CURTISS P-40
BULLETINS

TECHNICAL ORDER
No. 01-25C-7

CURTISS—OPERATION, MAINTENANCE, AND INSTALLATION INSTRUCTIONS FOR CARBURETOR AIR FILTERS—P-40E, P-40E-1, P-40K SERIES AND P-40M

Figure 4 - Relocation of Propeller
Relay Box Assembly

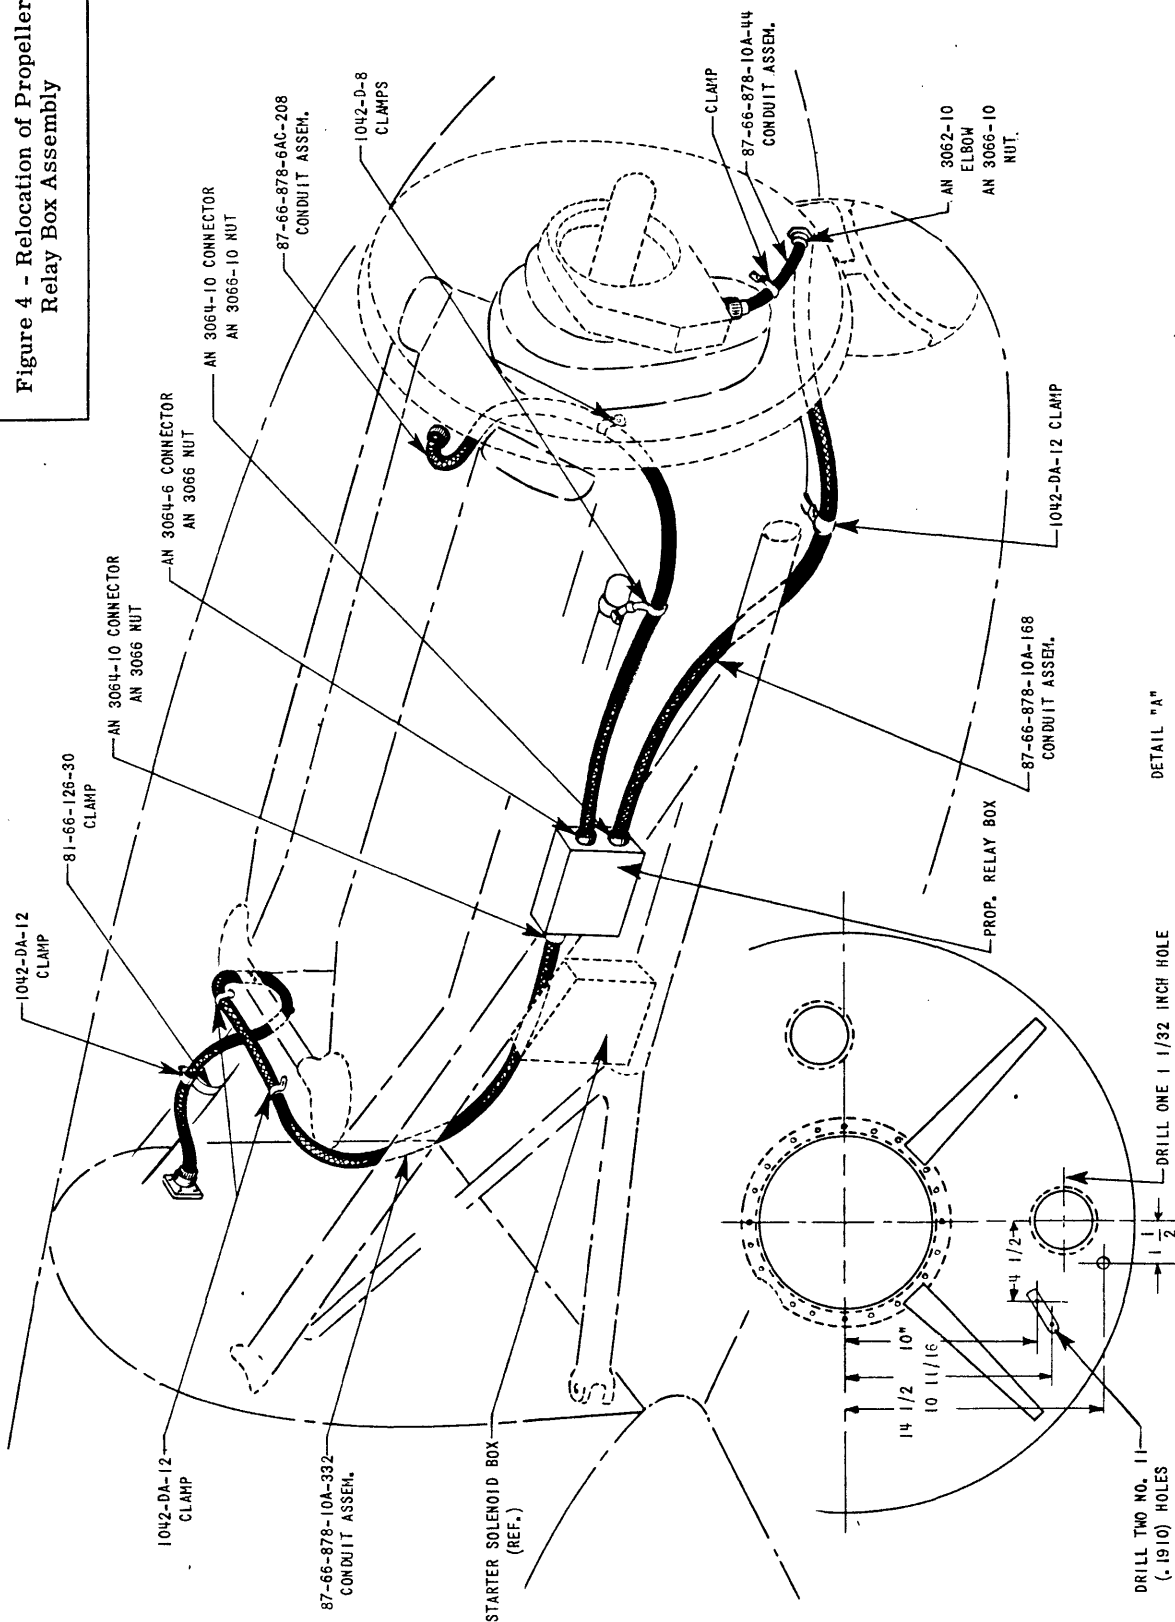
(4) Lay off and drill one 1-1/32 inch diameter hole and two No. 11 (.1910-inch) holes on the forward engine cowl bulkhead as shown in figure 4, detail "A."

(5) Slip two clamps, part No. 81-66-126-30, over the engine mount. Attach the clamps on the back of the propeller relay box using bolts, part No. AN3-31A, washers, part No. 960-10, and nuts, part No. 365-1032, and space the propeller relay box approximately 3-1/2 inches from the starter solenoid box. (See figure 4.)

(8) Remove the two screws, washers, and nuts, holding bracket on the face of the forward engine cowl bulkhead, which previously held circuit in place, and replace it where the two new No. 11 (.1910-inch) holes have been drilled, using two bolts, part No. AN3-4, two washers, part No. AN960-10, and two nuts, part No. 365-1032. (See figure 4, detail "A.")

(9) Secure conduit assembly, part No. 87-66-878-10A-168, to the bottom of the engine with clamp, part No. 1042-DA-12, by removing the second nut from the right-hand side. Install clamp and secure with original nut as shown in figure 4.

(10) Install conduit assembly, part No. 87-66-878-6AC-208, to the propeller governor and to the propeller relay box and holding it to the engine with two clamps, part No. 1042-D-8, as shown in figure 4. Install the wires to their respective terminal posts of the propeller relay.

(11) Install conduit assembly, part No. 87-66-878-10A-332, to the left-hand side of the propeller relay box and to the connector on the left-hand side of the fire wall, routing it between the rear top end of the engine and the carburetor. Attach the wires to their respective terminal posts. (See figure 4.)

(12) Remove the two screws that connected the removed conduit to the aft portion of engine as indicated in figure 4 and secure conduit assembly, part No. 87-66-878-10A-332, to the engine with two clamps, part No. 1042-DA-12, and replace the screws.

↓ Figure 5 - Air Intake Elbow Installation

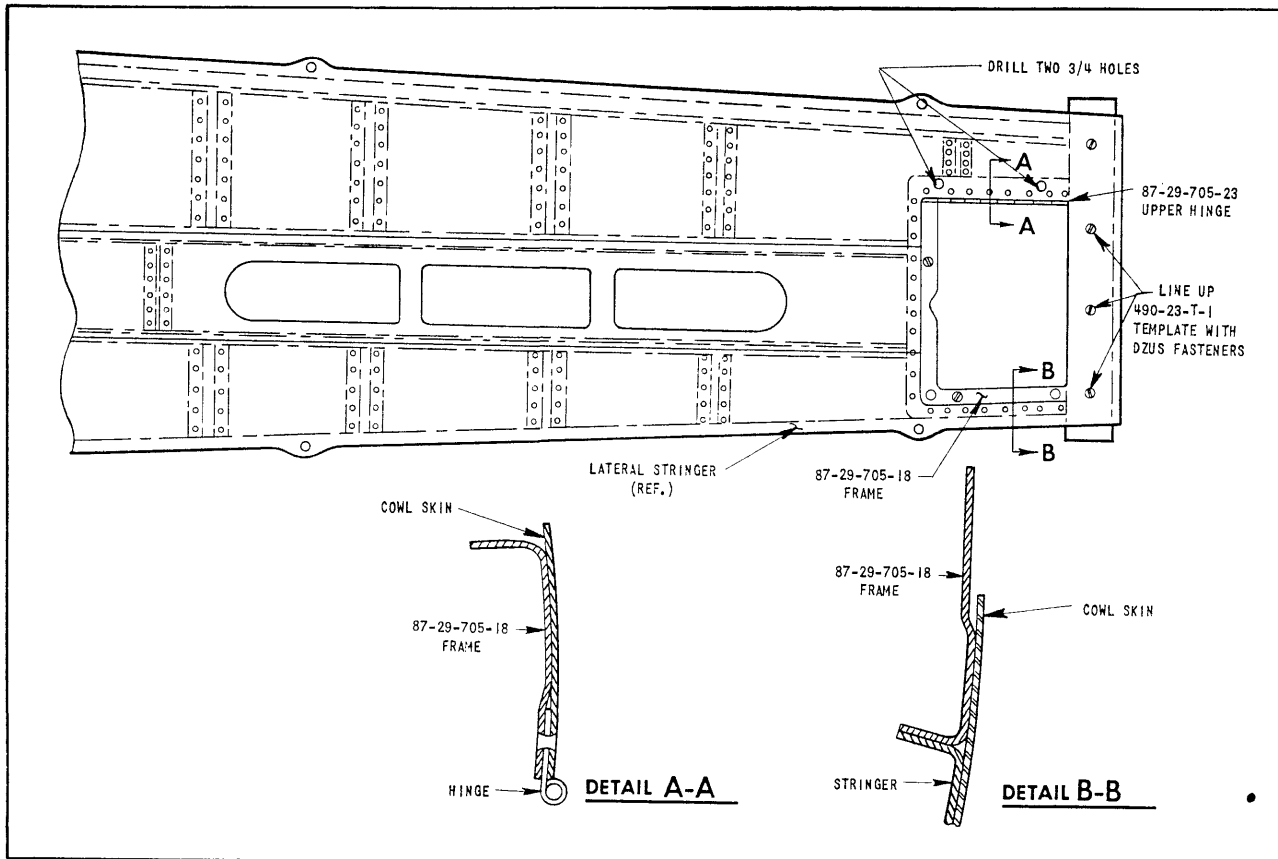
(1) Turn the top cowling over and cut bottom section of the carburetor air intake duct between the forward hat section and duct forging. Remove all rivets from the flange and hat section and four rivets on the left- and right-hand side of the forward air intake duct where the bottom part is removed. Enlarge rivet holes with a No. 10 (.193-inch) drill. (See figure 5.)

(2) Place the air filter intake elbow assembly, part No. 87-29-792-145, over the cut-out in the air intake duct and trim aft flange of the air filter elbow assembly to obtain a snug fit between the duct forging and the raised part of the hat section. (See figure 5.)

(4) Remove the two rivets from the duct forging that matches the two mounting holes on bracket, part No. 87-29-972-160. Enlarge the holes in the two brackets and forging using No. 10 (.193-inch) drill. (See figure 5.)

(5) Assemble air filter intake elbow, part No. 87-29-792-145, to the air intake duct using 19 screws, part No. 525-10-7, washers, part No. 960-10, and nuts, part No. 365-1032. (See figure 5.)

(6) Bolt the two brackets, part No. 87-29-972-160, to the forging with two screws, part No. 525-10-9, washers, part No. 960-10, and nuts, part No. 365-1032. (See figure 5.)

(8) Remove the two rivets on each side of the channel of the top cowl just forward of the hat section and rivet channel, part No. 87-29-792-141, to the channel of the top cowl with four rivets, part No. AN442AD4-5. (See figure 5.)

Figure 6 - Air Filter Frame Installation

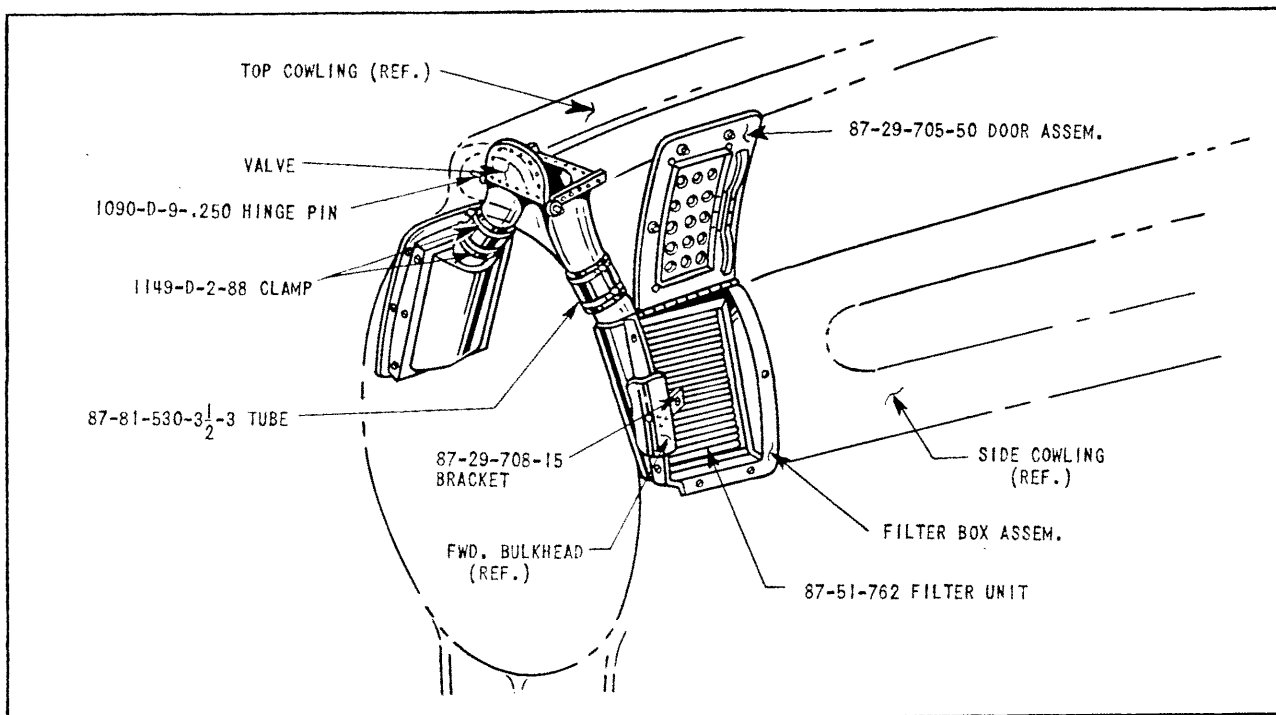
holes of template, part No. 490-23-T-1, with the three lower Dzus fasteners on the forward end of the side cowling and drill two No. 41 (.0960-inch) holes on the top through the cowling. (See figure 6.)

(2) Cut out the part of cowling and reinforcements within the scribed line and file cowling evenly to scribed line. Enlarge the two No. 41 holes to 3/4-inch diameter. (See figure 6.)

(3) Place frame, part No. 87-29-705-18, on the inside of the cowling so that the bottom of the frame rests against bottom stringer of the cowling and the two clearance holes in the top for the Dzus fasteners in the frame line up with the two 3/4-inch holes in the cowling. Cut the two lateral angle stringers and stiffener to allow frame, part No. 87-29-705-18, to lay against the skin of the cowling. (See figure 6 and detail.)

(5) Rivet the frame to the cowling with 29 rivets, part No. 673D4AD4, the hinge with 8 rivets, part No. 673D4AD5, and the flange on the bottom of the frame to the lateral stringer with 8 rivets, part No. AN455D4-4. (See figure 6.)

Figure 7 - Installation of Air Filter Assembly

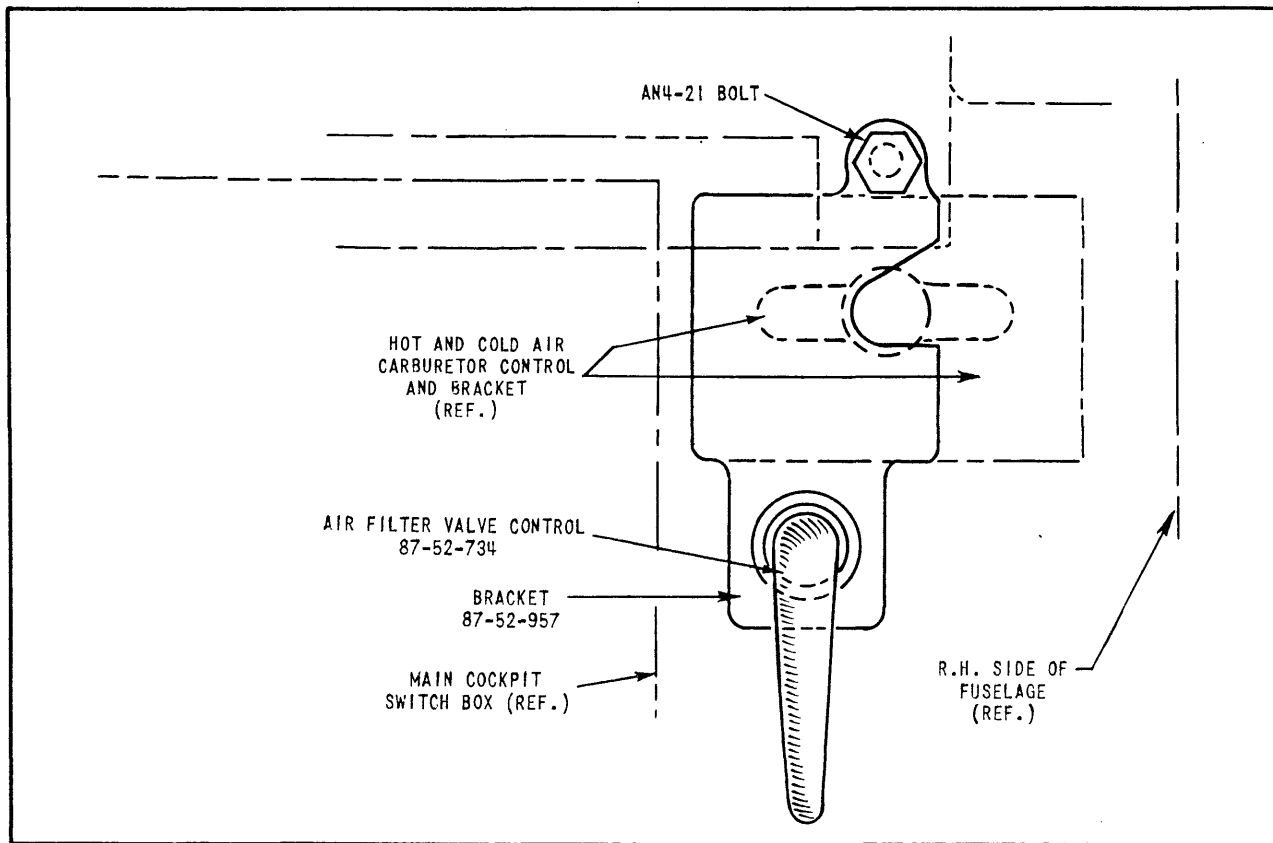
(6) Replace the side cowling to the airplane and lock the filter door. Attach bracket, part No. 87-29-708-15, to the Dzus fasteners on the inside of the door and scribe the four holes to the flange of the forward bulkhead of the airplane. (See figure 7.)

(8) Remove the side cowling from the airplane and enlarge the four holes in the flange of the forward bulkhead and bracket, part No. 87-29-708-15, with a No. 30 (.1285-inch) drill. Countersink the four holes on the outside of the flange of the forward bulkhead and rivet the bracket to the inside of the flange with four rivets, part No. 673D4AD6. (See figure 7.)

(9) Remove the filter box from the cowling and install it on to the forward bulkhead with three screws, part No. 526-428-7, washers, part No. 960-416L, and nuts, part No. 365-428. (See figure 7.)

(10) Attach a clamp, part No. 1149-D-2-88, on each of the tubes, part No. 87-81-530-3 1/2-3, and attach tubes to the air filter intake elbow assembly, part No. 87-51-768. (See figure 7.)

Figure 9 - Installation of Air Filter Control

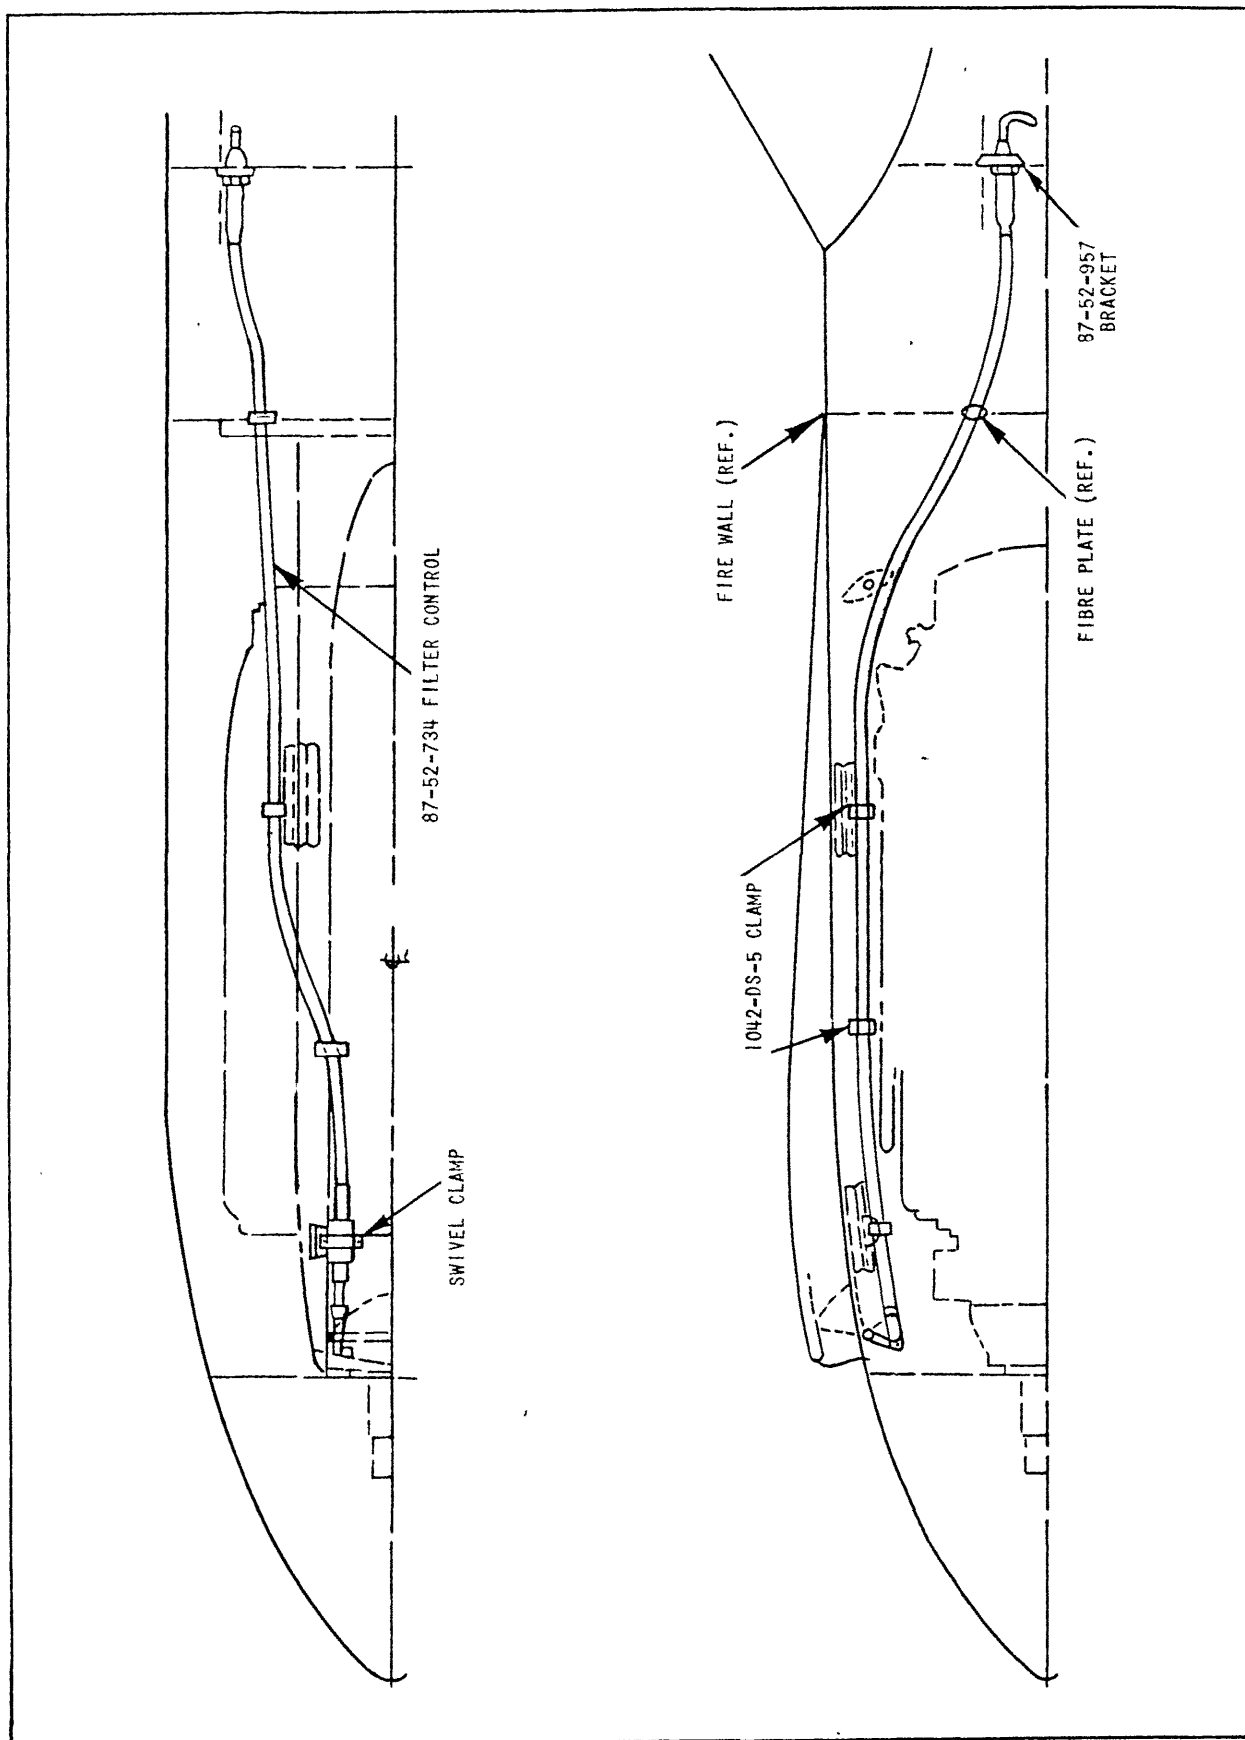
pit on the right-hand side of the fuselage and through the 3/8-inch diameter hole previously enlarged in the fiber plate at the fire wall. (See figure 9.)

(5) Replace the top cowling on the airplane and route the air filter control, part No. 87-52-734, along the right-hand cowling through the swivel clamp. Attach clevis end to the control and secure clevis end to the arm of the air filter intake elbow assembly, part No. 87-29-792-145, with bolt, part No. AN3-6, nut, part No. AN310-3, three washers, part No. 960-10, and one cotter pin, part No. AN380-2-2. (See figures 5 and 9.)

(6) Secure the air filter control to the screw of the Adel clamp forward of the fire wall which holds the three fuel lines using a clamp, part No. 1042-DS-5, and to the channel of the top cowling where the rivet has been removed, as outlined in paragraph 3.c.(10) with a clamp, part No. 1042-DS-5, screw, part No. 525-1032-7, washer, part No. 960-10, and stop nut, part No. 365-1032. (See figure 9.)

Figure 1 - Installation "695-G" Switches - Starboard
Side of Cockpit

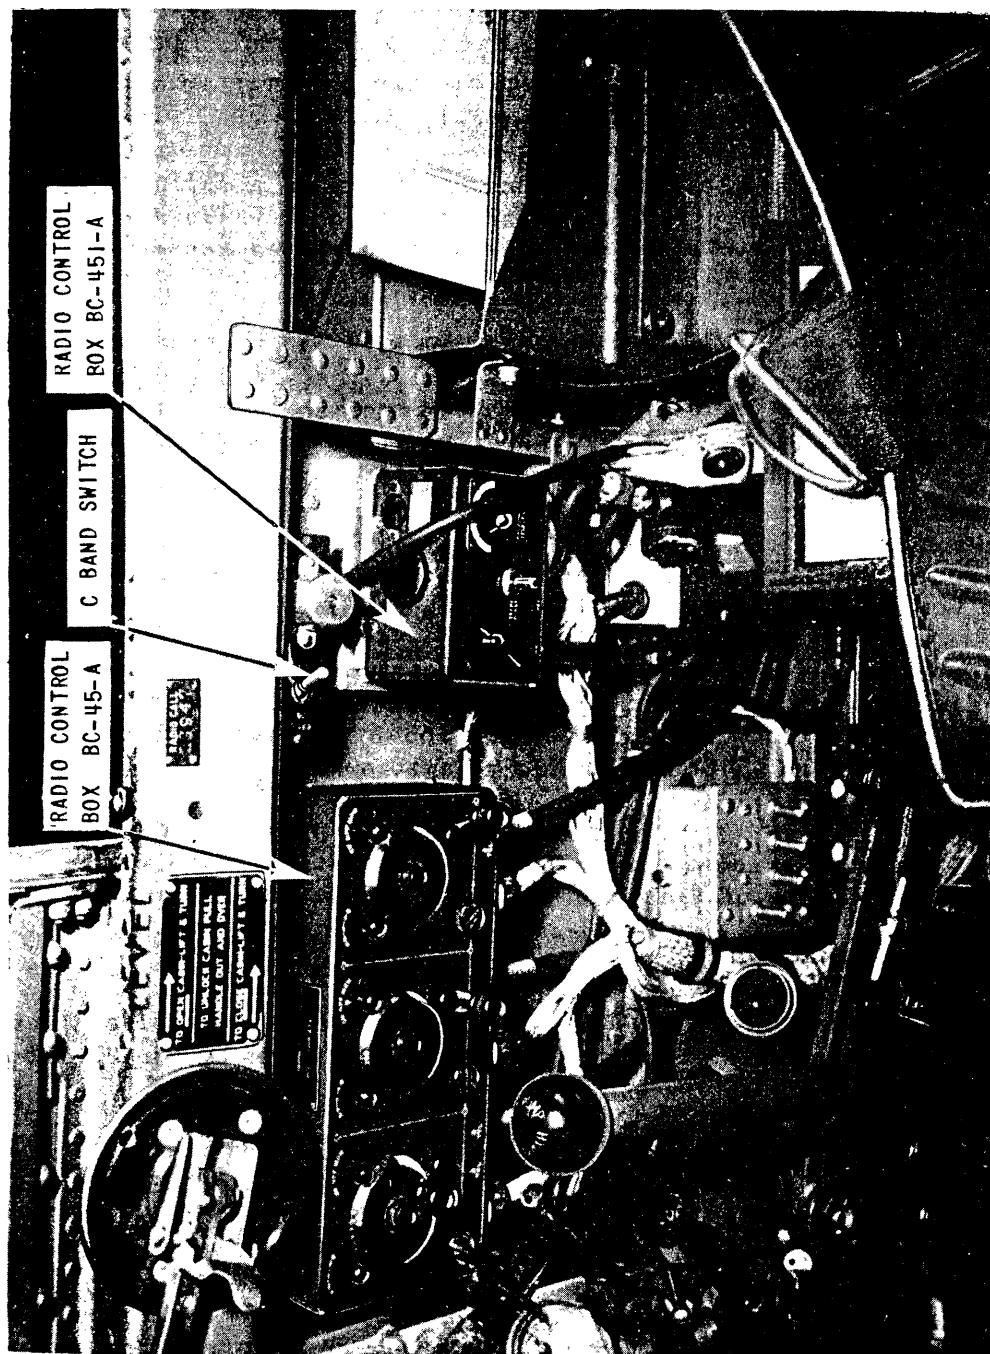
a. INSTALLATION OF REMOTE "EMERGENCY"
AND "695-G" SWITCHES. (See figure 1.)

b. INSTALLATION OF REMOTE "EMERGENCY" AND "IFF ON-OFF" SWITCHES AND "695-G" SWITCHES IN P-40D AND P-40E AIRPLANES, PRIOR TO AF SERIAL NO. 41-5522. (See figure 1.)
